11302, 11306, 11308, 11312, 11316, 11320, 11322 and 11326 - 79 Street NW; 11303, 11305, 11307, 11311, 11315, 11317, 11321 and 11323 - 80 Street NW; and 7300 - 116 Avenue NW
Position of Administration: Support

Bylaw 21234 proposes a rezoning from the Urban Facilities Zone (UF) and the Medium Scale Residential Zone (RM h16.0) to the Public Utility Zone (PU) to allow for the development of stormwater management facilities (SWMFs). Charter Bylaw 21232 proposes an amendment to the North Central District Plan to facilitate the proposed rezoning. Bylaw 21233 proposes an amendment to the Exhibition Lands Planning Framework (ELPF) to facilitate the proposed rezoning.

Exhibition Lands Planning Framework (ELPF) Summary of Proposed Amendments

Exhibition Lands Planning Framework Proposed Figure Amendments

Proposed Figure 13 Land Use Concept Map (see legend below)

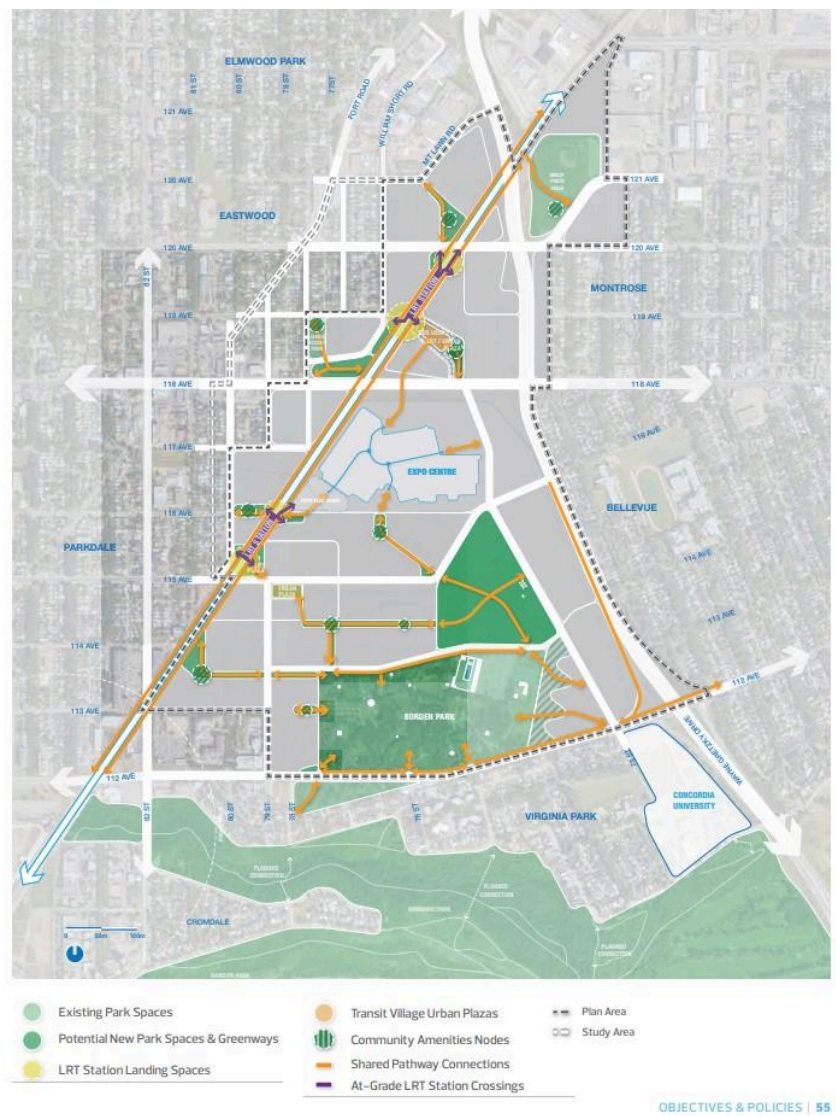
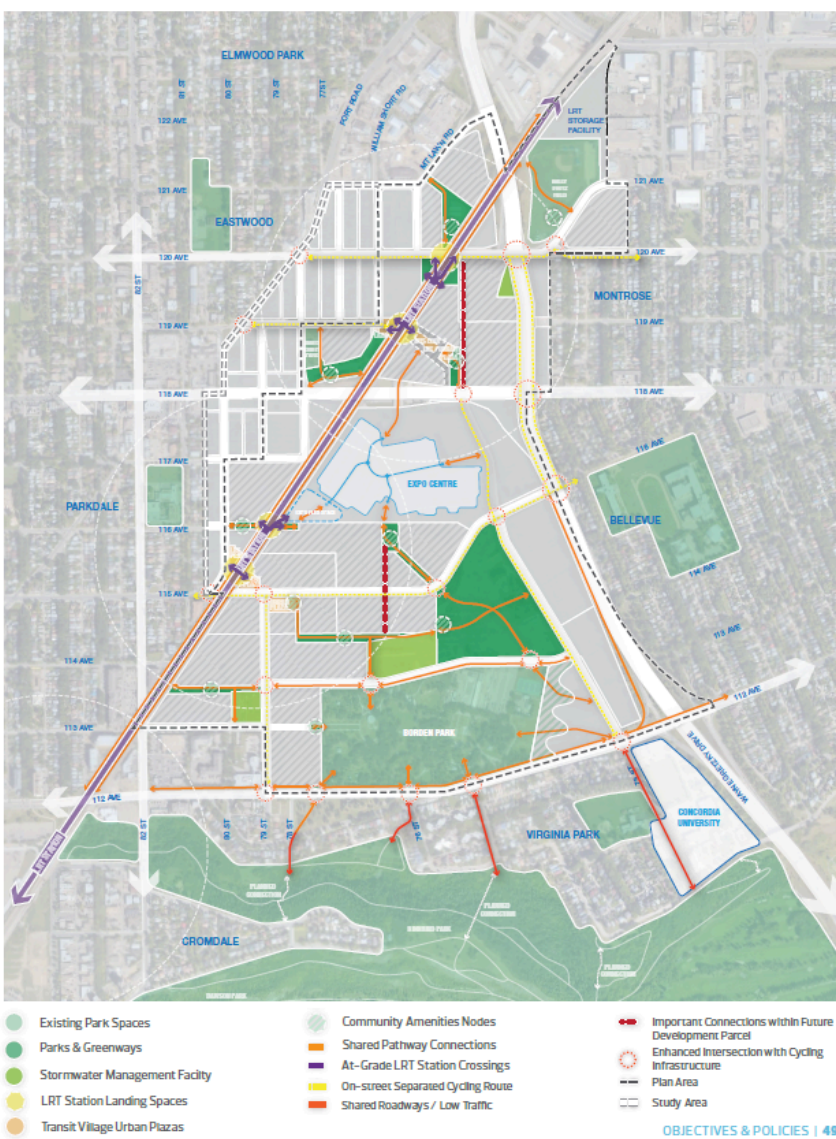
Figure 13 Land Use Concept Map Legend	No maximum 8 storey maximum	Employment Anchor Policy 4.1.4.b states: 'Allow a maximum building height of 8 storeys'.

Employment Anchor P.g. 38		Adding '8 storey maximum' the legend to align with the policy, and maintain consistency throughout the plan.
Figure 13 Land Use Concept Map Legend Industrial Transition P.g. 38	Warehouse / studio, live-work, row house, stacked row house, low rise apartment, Mid-rise apartment	Industrial Transition Policy 4.1.7.b states: 'Require a minimum height of 2 storeys and allow a maximum building height of 6 storeys.' Adding 'Mid-rise apartment' to the list of built forms to align with the policy, and maintain consistency throughout the plan.
Figure 13 Land Use Concept Map Legend Park P.g. 38	Open Space Park	Replaced 'open space' with 'park' to use the appropriate term.
Figure 13 Land Use Concept Map Legend Stormwater Management Facility P.g. 38	Stormwater Management Facility Refer to Section 4.3 Open Space Not applicable	New legend item to reflect the addition of the Stormwater Management Facilities.

<ul style="list-style-type: none"> - Clearly showing Borden Park Road NW - Aligned parks with the Parkland Impact Assessment (PIA) - Mapping updates to more accurately represent the land use areas on the figure 	
<p>Figure 13 Land Use Concept Map</p> <p>P.g. 39</p>	<ul style="list-style-type: none"> - Renamed from 'Figure 16 Land Use Concept Map' - Added existing and proposed SWMFs in alignment with the Neighbourhood Design Report (NDR) - Aligned parks with the Parkland Impact Assessment (PIA) - Mapping updates to more accurately represent the land use areas on the figure 	
<p>4.1.1 Mixed Use Transit Village Node - South Vignette</p> <p>P.g. 40</p>	<ul style="list-style-type: none"> - Park space updated to align with the Parkland Impact Assessment (PIA) - Mapping updates to more accurately represent the land use areas on the figure 	<p>Figure numbers updated to reflect reordering.</p> <p>All figures were updated to more accurately represent the land use areas. The statistics and figures are now aligned.</p>

Proposed Figure 22 Open Space Concept Map

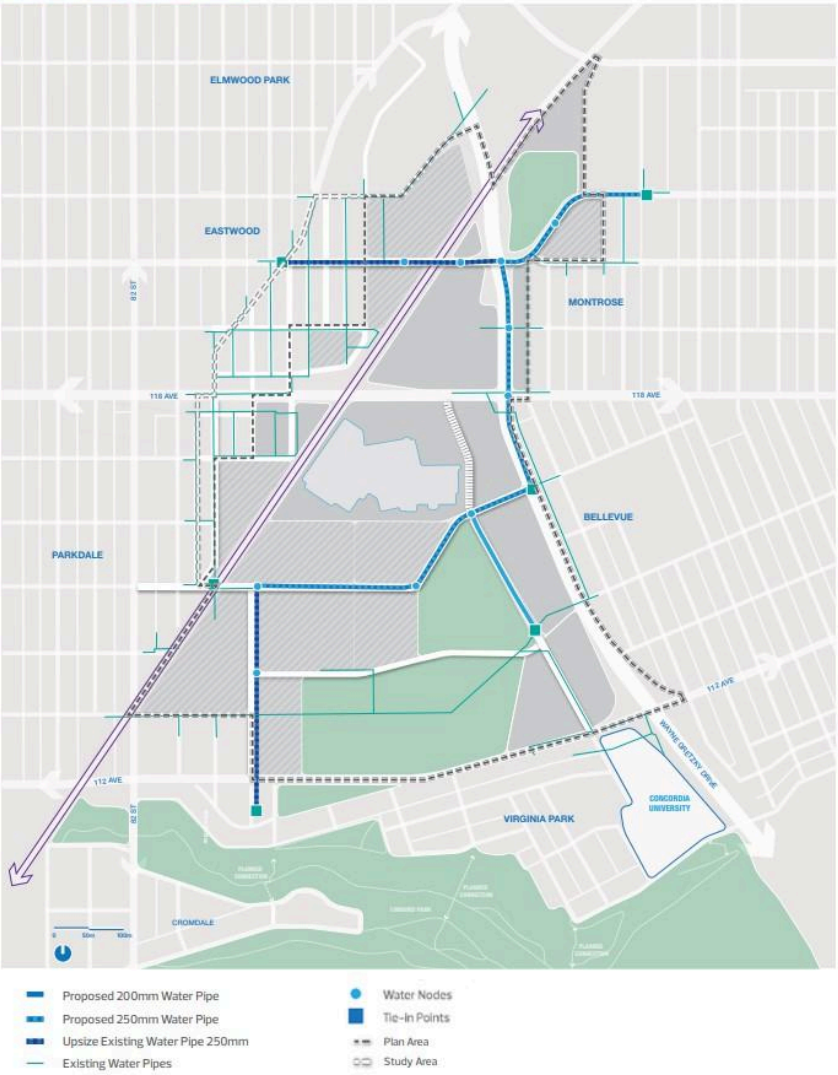
4.1.6 EXPO Centre Vignette P.g. 45	- Mapping updates to more accurately represent the land use areas on the figure.	
4.7 Industrial Transition Vignette P.g. 45	- Mapping updates to more accurately represent the land use areas on the figure.	
Figure 22 Open Space Concept Map P.g. 49	<ul style="list-style-type: none"> - Renamed from 'Figure 25: Open Space Concept Map' <p>Legend:</p> <ul style="list-style-type: none"> - 'Potential New Park Spaces and Greenways' revised to 'Parks and Greenways' - Added 'Stormwater Management Facility' - Added 'On-street Separated Cycling Route' - Added 'Shared Roadways/Low Traffic' - Added 'Important Connections with Future Development Parcel' - Added 'Enhanced Intersection with Cycling Infrastructure' <p>Figure:</p> <ul style="list-style-type: none"> - Added existing and proposed SWMFs in alignment with the Neighbourhood Design Report (NDR) - Aligned parks with the Parkland Impact Assessment (PIA) - Mapping updates to more accurately represent the land use areas on the figure 	<p>All figures were updated to more accurately represent the land use areas. The statistics and figures are now aligned.</p> <p>Stormwater Management Facilities added to the legend and the figure to reflect the proposed servicing approach in alignment with the accepted Neighbourhood Design Report (NDR). Stormwater Management Facilities were not contemplated in the current ELPF.</p> <p>Parks were updated in alignment with the Parkland Impact Assessment (PIA), including the integration of Stormwater Management Facilities into the open space network.</p> <p>Updates to the shared pathway connections network to integrate the Stormwater Management Facilities with the active transportation network (e.g. addition of a shared pathway connection on the west side of the proposed western SWMF)</p> <p>Added legend items (e.g. on-street separated cycling</p>

Proposed Figure 31 Sanitary Sewer Servicing Map

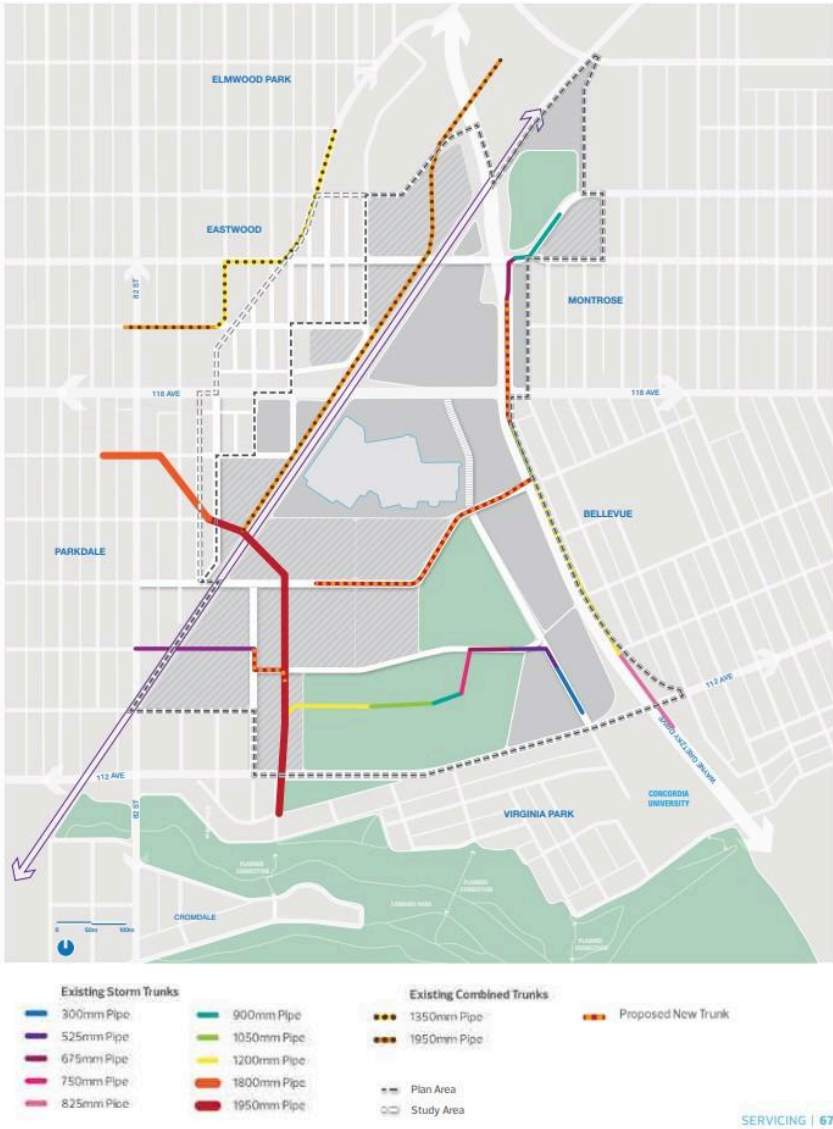
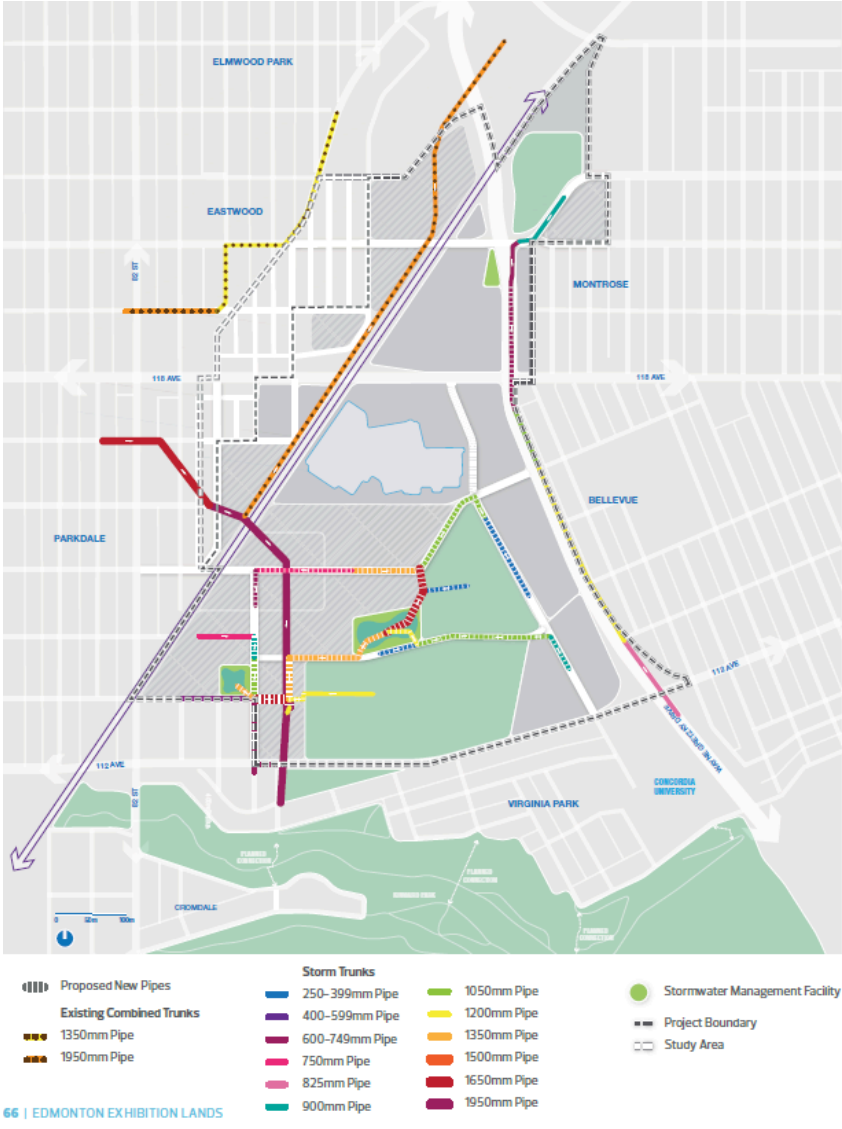
<p>Figure 31 Sanitary Sewer Servicing</p> <p>P.g. 65</p>	<ul style="list-style-type: none"> - Added existing and proposed SWMFs in alignment with the Neighbourhood Design Report (NDR) - Changes to the sanitary sewer servicing figure as per the NDR.

Proposed Map 1: Heritage and Culture

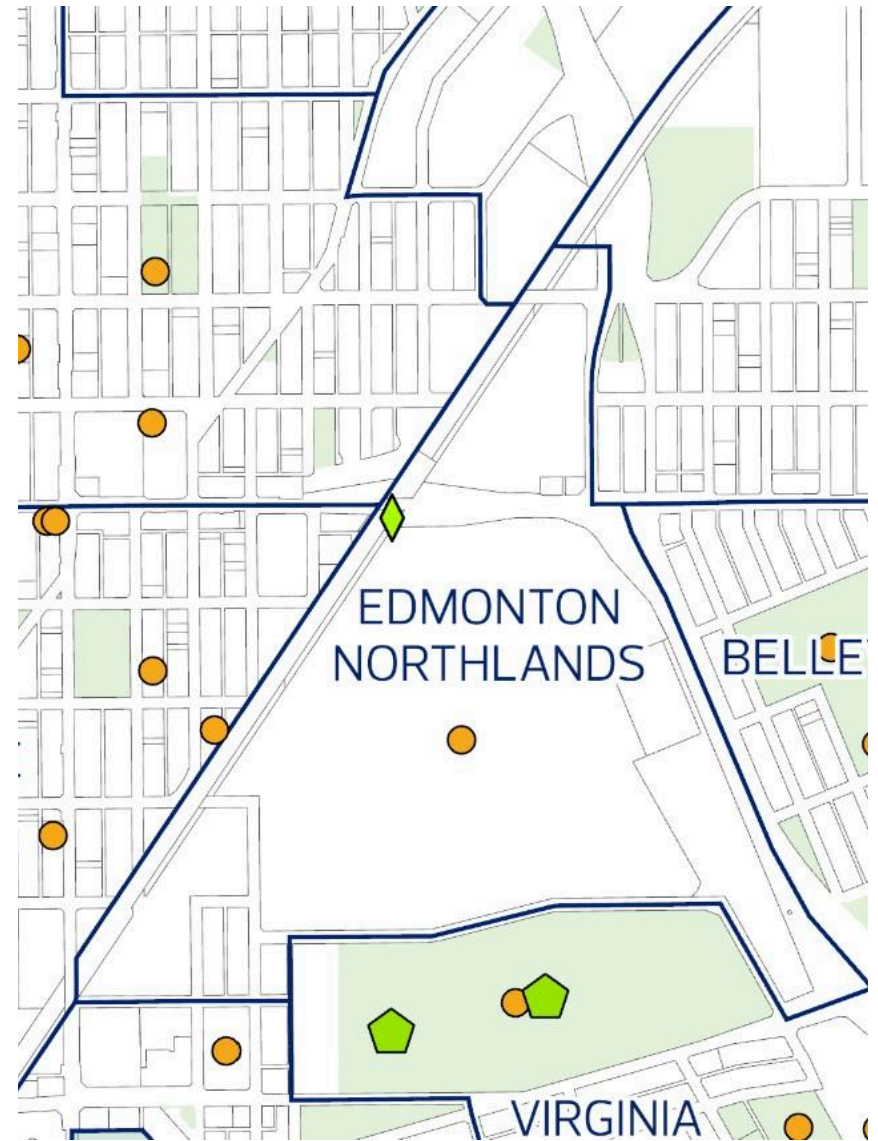
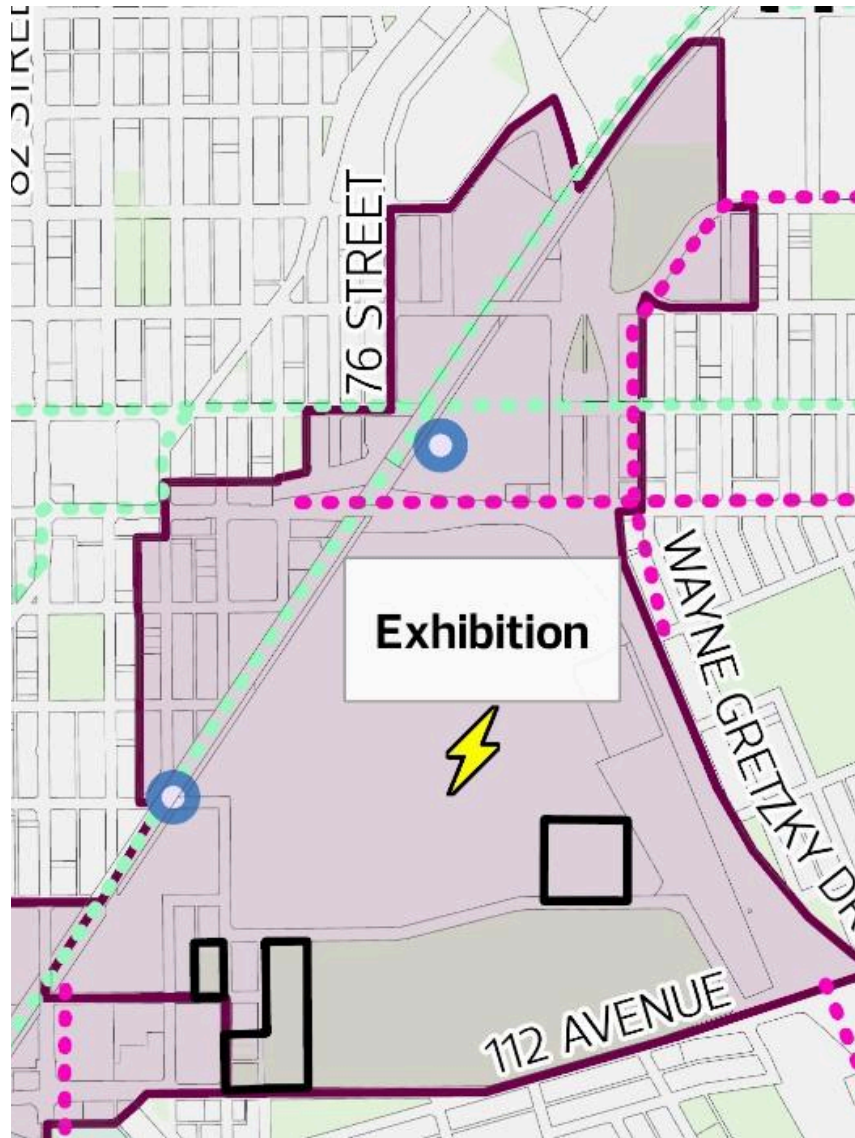
- Map 1: Heritage and Culture, Map 2: Activating Growth to 1.25 Million, and Map 3: Nodes and Corridors: remove the 'open area' designation.
- Map 4: Land Use Concept to 1.25 Million: redesignate from 'urban mix' and 'open space - current' to 'urban service'.
- Map 5: Open Space and Natural Areas to 1.25 Million: remove 'special purpose facility' designation.

Proposed Map 2: Activating Growth to 1.25 Million

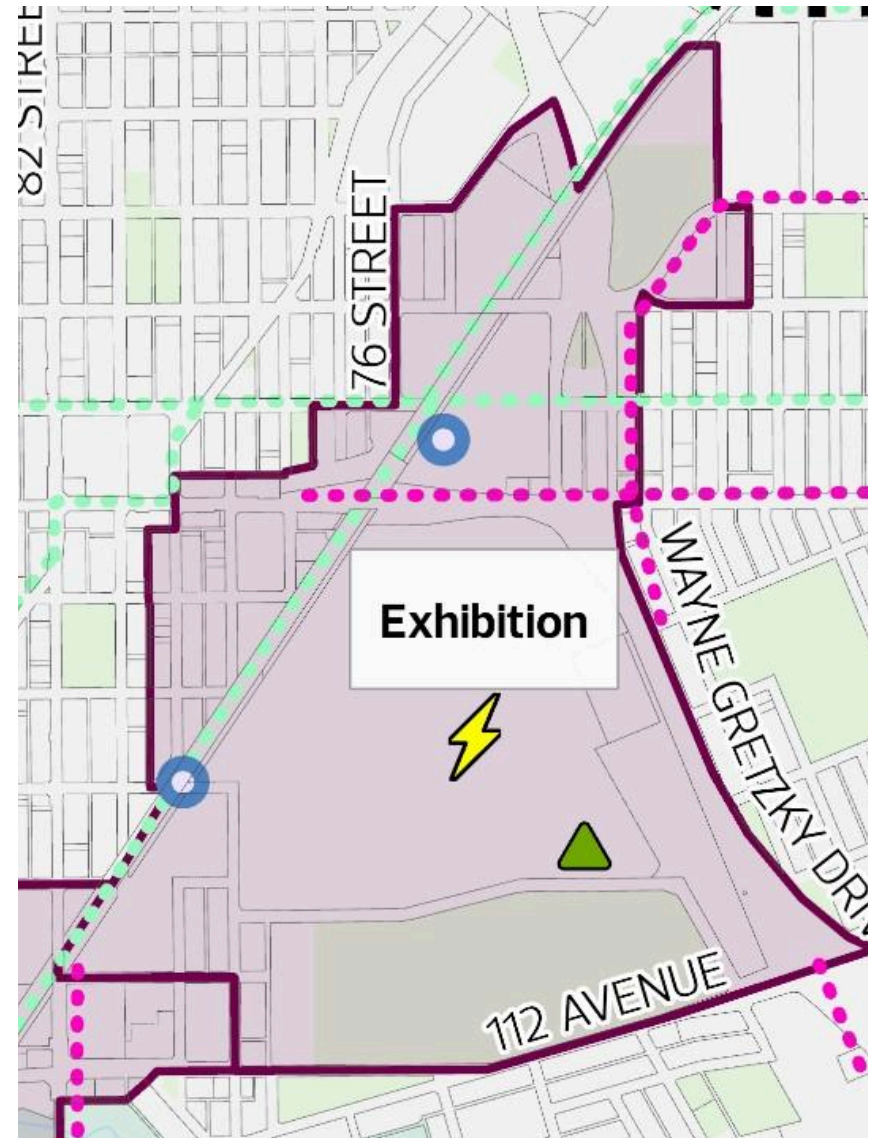
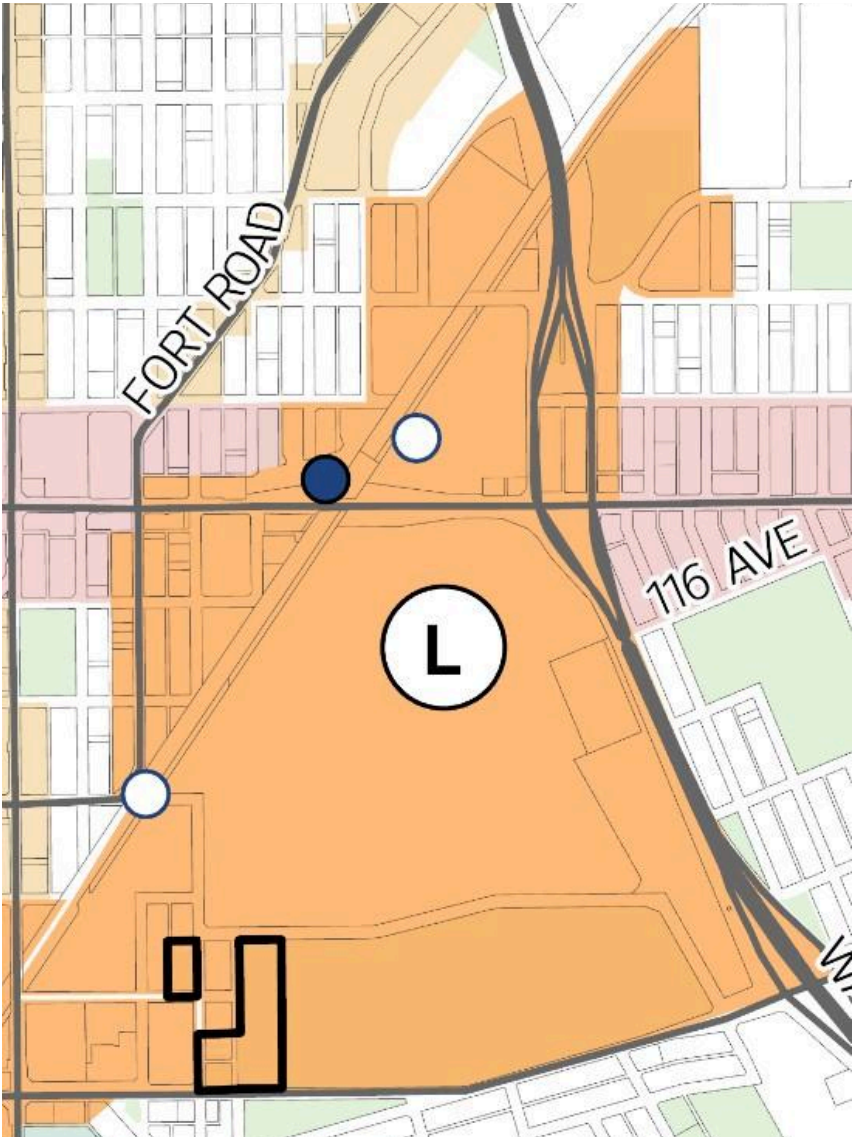
In the Exhibition Lands Planning Framework (ELPF), an expansion to Borden Park is proposed. A 'medium - planned municipal park' icon has been added to Maps 2, 4, and 5 to reflect this.
